Product Change Notification

Change Notification #: 118625-03
Change Title: Select Intel® Server System R2312WFTZSR, Intel® Server System R2308WFTZSR, Intel® Server System R2224WFTZSR, Intel® Server System R2208WF0ZSR, Intel® Server System R2208WFTZSR, Intel® Server System R1208WFTYSR, 2U Rear Hot-swap Dual Drive Cage Upgrade Kit A2UREARHSDK2, 2U Hot-swap 8x2.5inch SAS/NVMe Combo Drive Bay Kit A2U8X25S3PHS, PCN 118625-03, Product Design, Product Material
Alternate Hot Swap Backplane
Reason for Revision: Rectify TA Numbers

Date of Publication: January 13, 2022

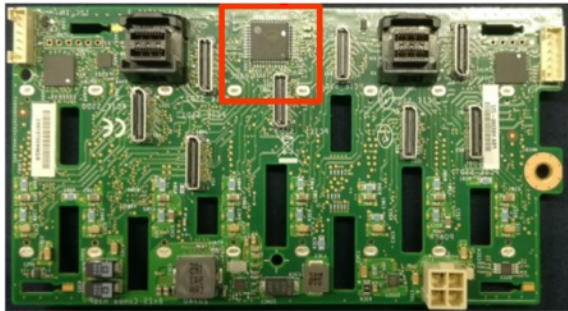
- Due to Integrated Circuit (IC) shortage from the supplier, a Programmable System-On-Chip (PSOC) used on the Hot Swap Backplanes needs to be replaced with an alternative component. The new component is identical in function than previous one but differs in form factor. For business continuity, demand fulfillment and to minimize customer impact, an interposer PCB supporting the new component was used. The new component has passed all functional and electrical validation test successfully.

PBA Code Before - H88386-252

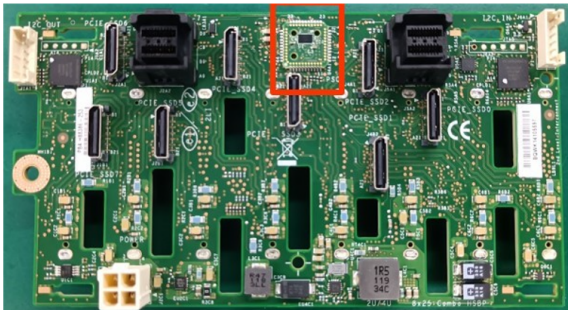
PBA Code After - H88386-253

PBA Code Before - G97160-372

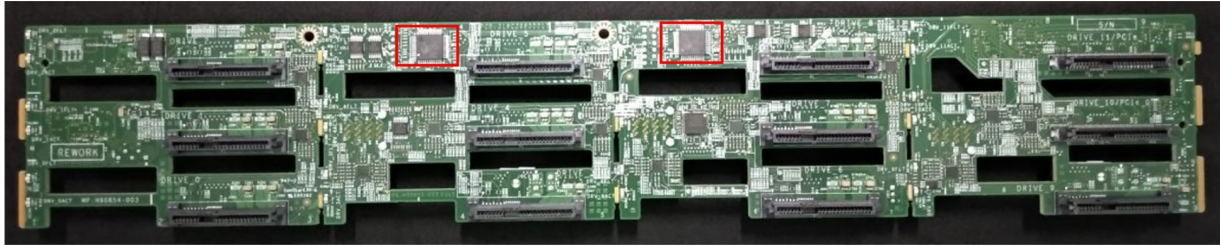
PBA Code After - G97160-373

PBA Code Before - H88392-351

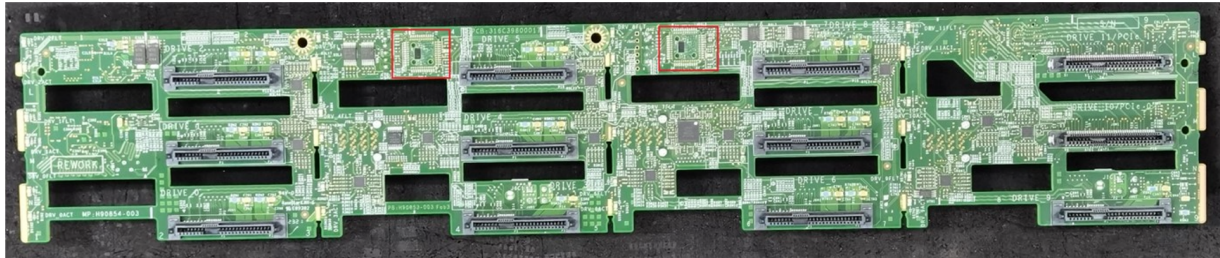
PBA Code After - H88392-352
